UNITED STATES
NUCLEAR REGULATORY COMMISSION
WASHINGTON, D. C. 20555

Docket No. 50-267

SUBJECT: SUMMARY OF NOVEMBER 20, 1986 MEETING WITH PUBLIC SERVICE
COMPANY OF COLORADO (PSC) TO DISCUSS FORT ST. VRAIN (FSV)
TEMPERATURE PROFILES FOR EQUIPMENT QUALIFICATION

THE ISSUE: APPROPRIATE VALUES FOR
HEAT TRANSFER COEFFICIENTS FOR
FORT ST. VRAIN STEAM LINE BREAKS

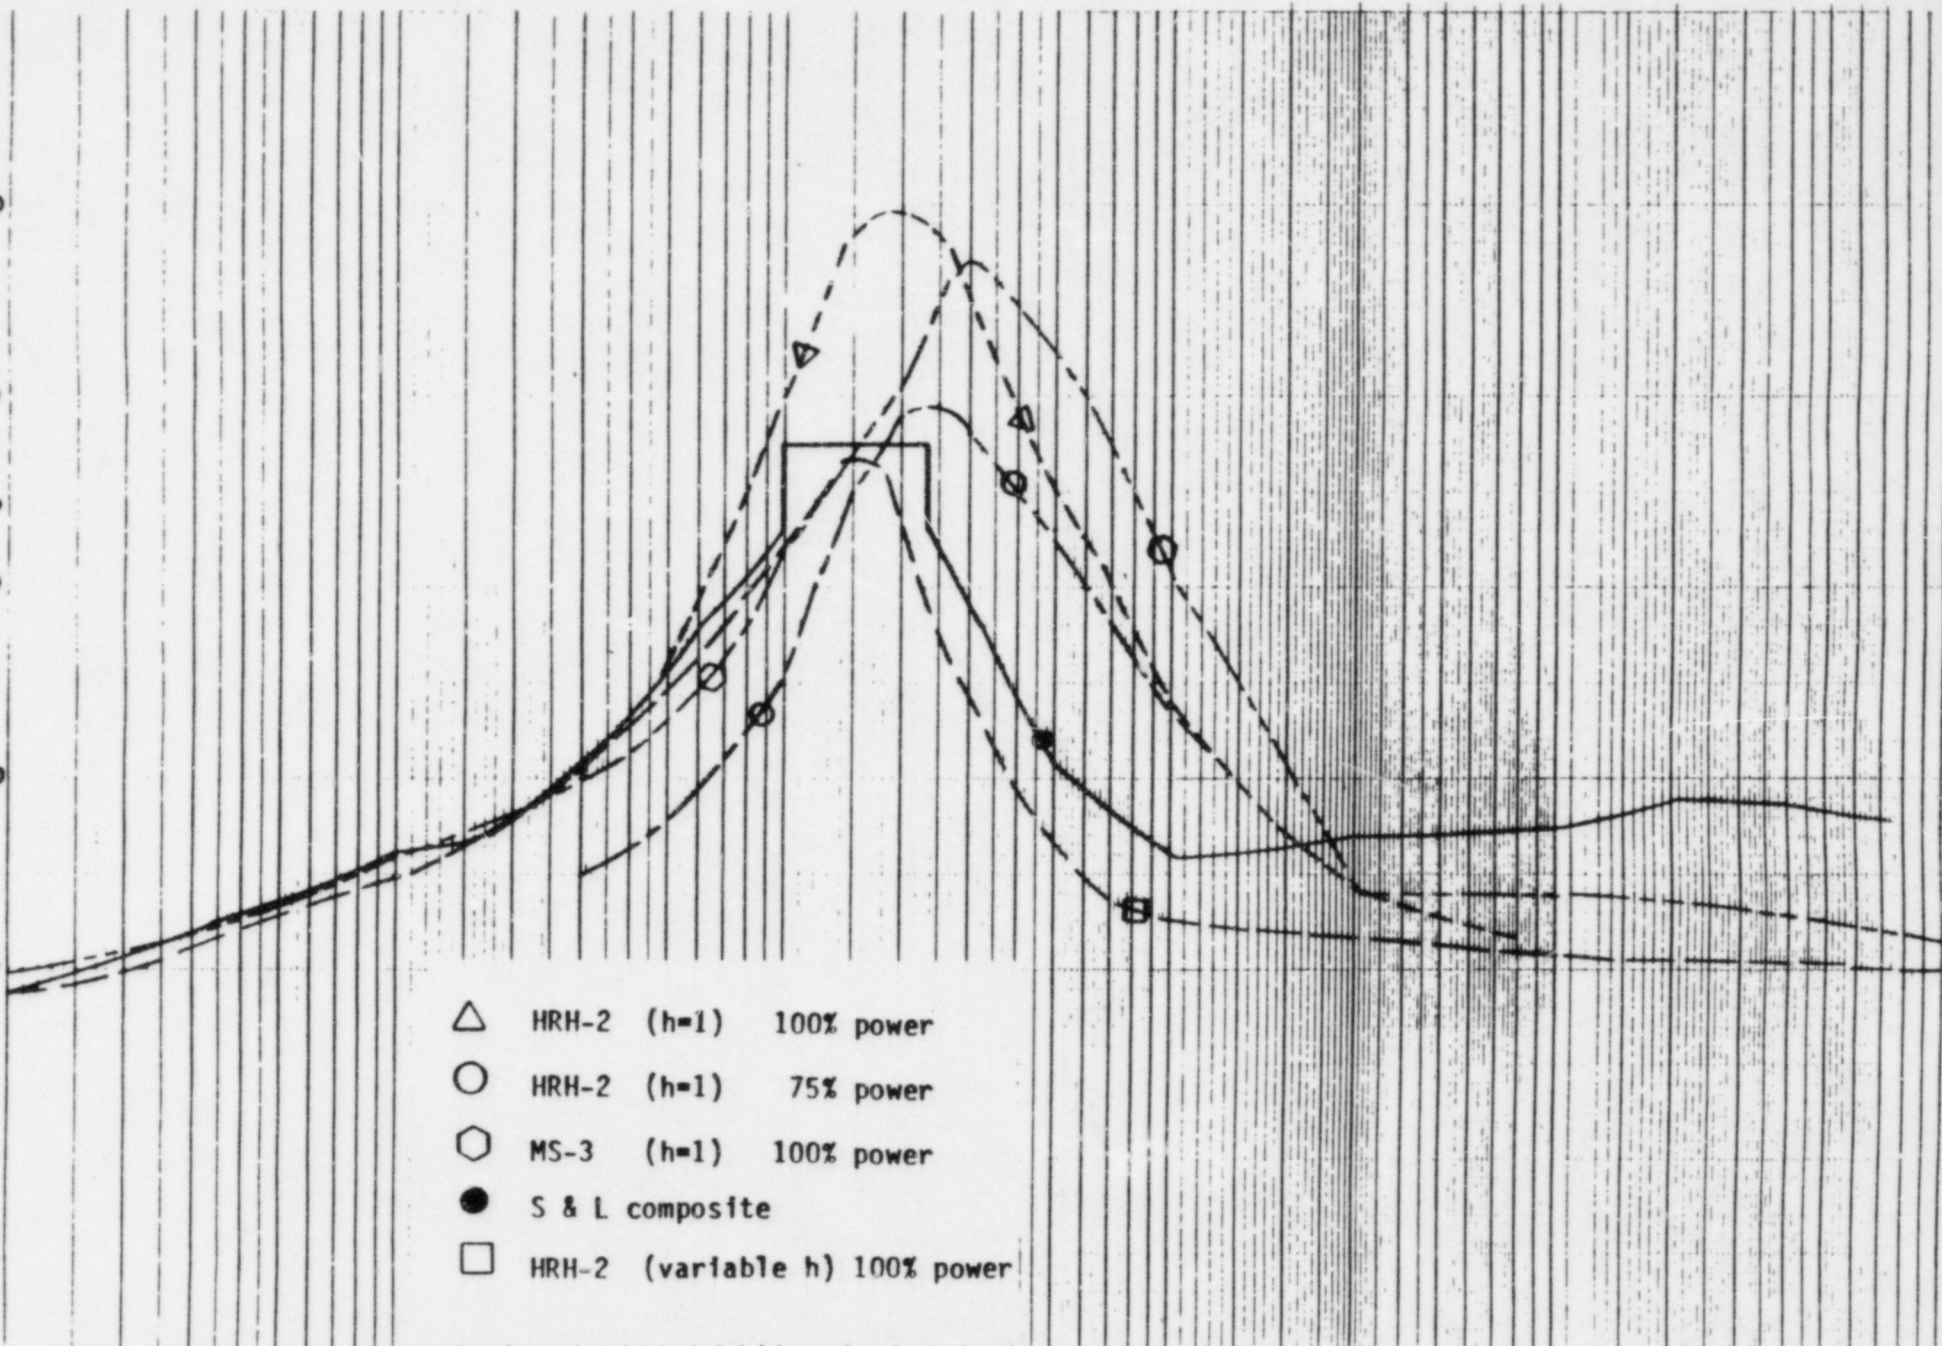
PSC presented a summary of their basis for concluding that their temperature profile calculations were conservative (see Enclosure 2). PSC stated that the different computer codes used by the staff's consultant and PSC were not the cause of the different temperature profiles. However, the lower heat transfer coefficients used by the staff's consultant were the primary cause of the differences. PSC noted the higher heat transfer coefficients that they had used were derived from original licensing calculations, and were accepted by the staff when the plant was originally licensed. PSC felt these heat transfer coefficients were still conservative.

PSC had investigated the possibility of taking credit for potential limitations in plant power level. However, preliminary calculations for scenario HRH-2 at 75 percent of full power still exceeded the design temperature profile.

- Use heat transfer coefficients similar in value to the staff's consultants (approximately one in English units),
- Use revised building volume and surface area parameters to reflect additional volumes where steam could easily penetrate, and
- Do the sample calculations for a large break (i.e., HRH-2), small break (i.e., CRH-19), and operator-isolated break. Three revised calculations should be done for each building.

HRH-2 BLOWDOWN ANALYSIS

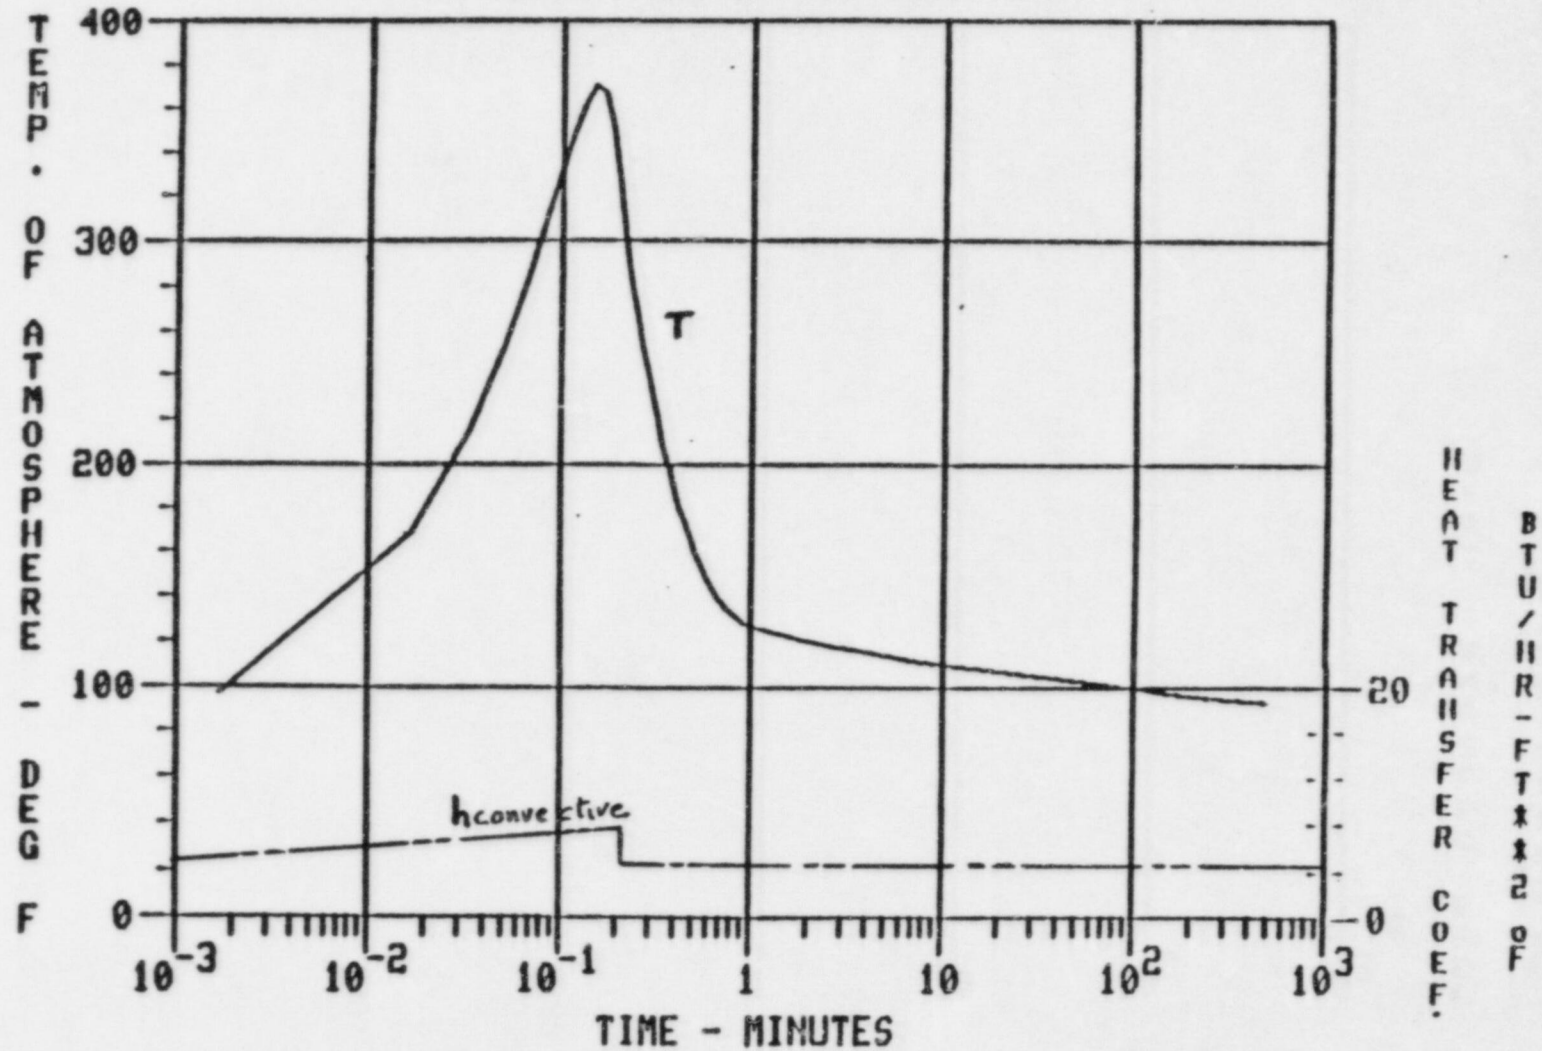
- H_{CONV} VARIES LINEARLY FROM 5 AT START TO 7.5 BTU/FT²-H-°F AT END OF BLOWDOWN
- H_{COND} IS BASED ON UCHIDA
- H_{TOTAL} IS ABOUT 15 BTU/FT²-H-°F AT END OF BLOWDOWN

Figure 1.2-2 Plan View of Reactor Building and Turbine Building

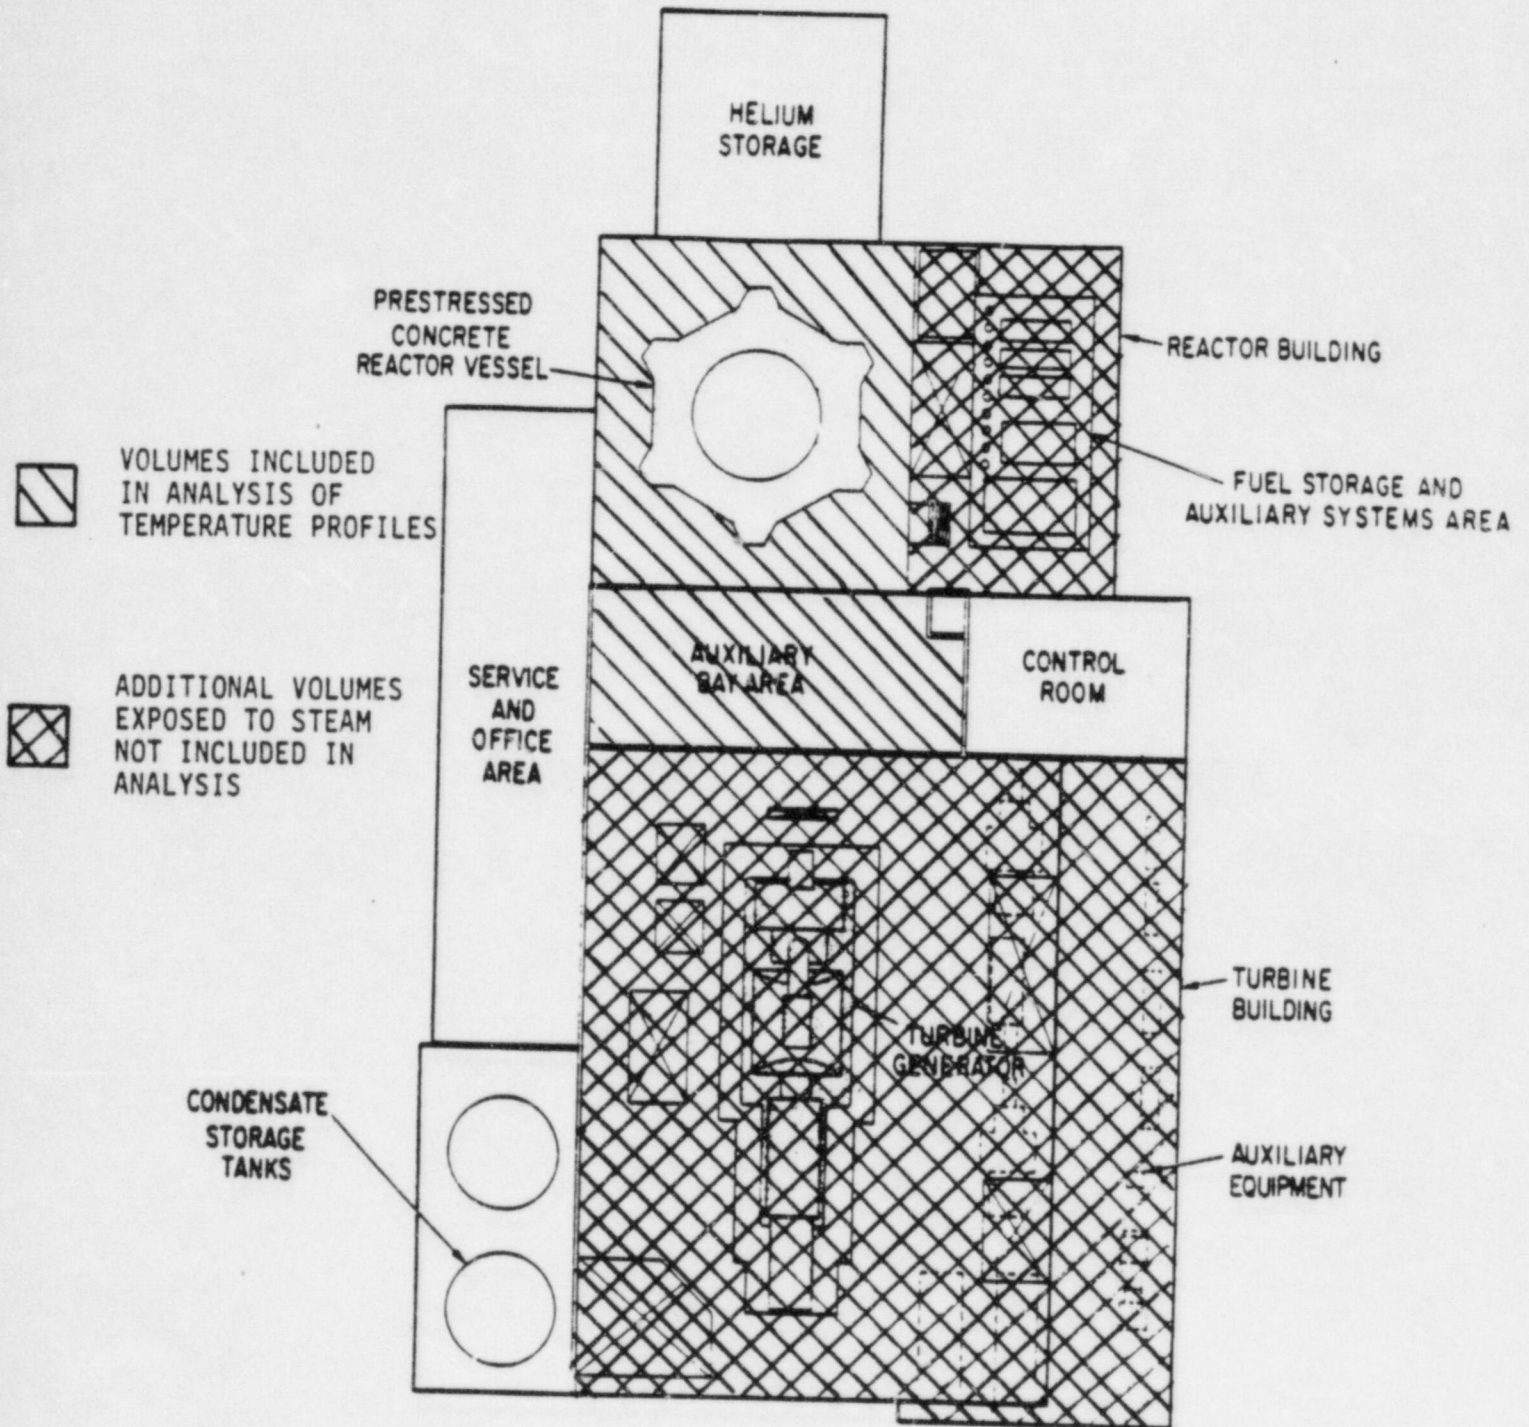
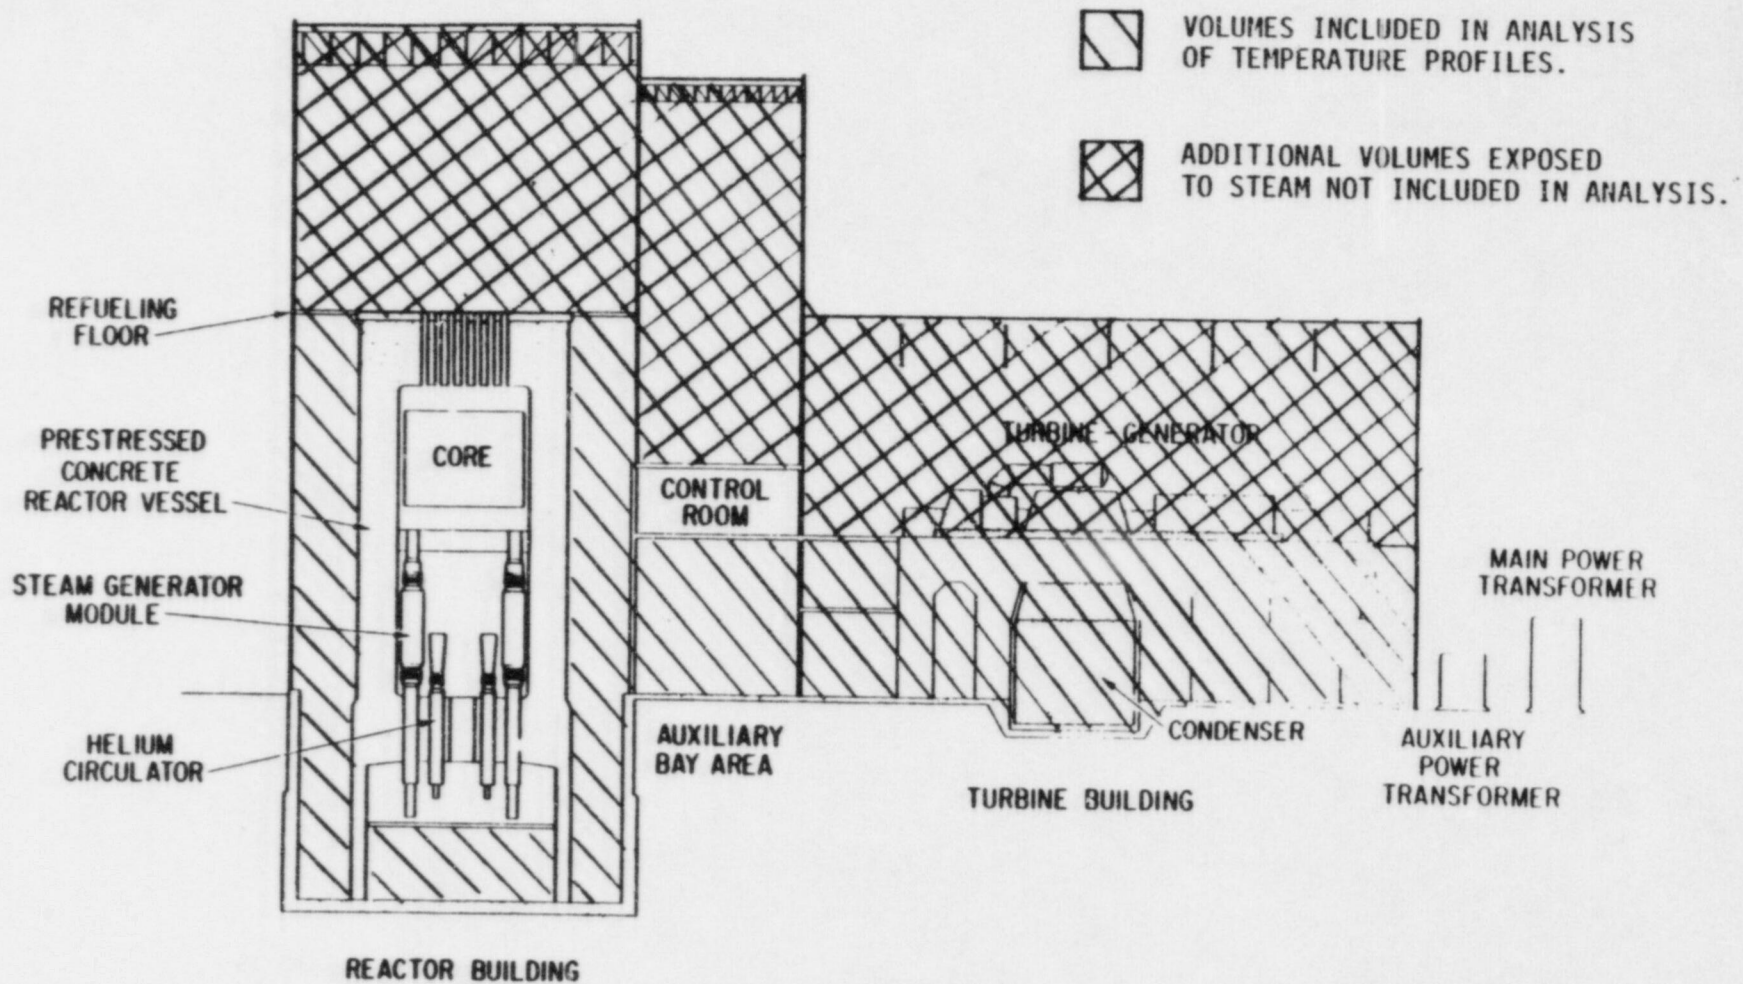
PSC further noted that large conservatisms existed in the restricted volumes they had used for their evaluations in the reactor and turbine buildings. The actual building volumes were considerably higher. However, preliminary calculations with less conservative building volumes gave much lower temperature profiles. PSC maintained that the temperature profiles used for equipment qualification could not easily be modified, since most of the equipment qualification files were complete. For certain critical components, such as cables, the margin in temperature for equipment qualification was small.

4. VOLUMES AND HEAT SINK AREAS UTILIZED IN THE CONTEMPT-G CALCULATIONS ARE CONSERVATIVELY LOW.
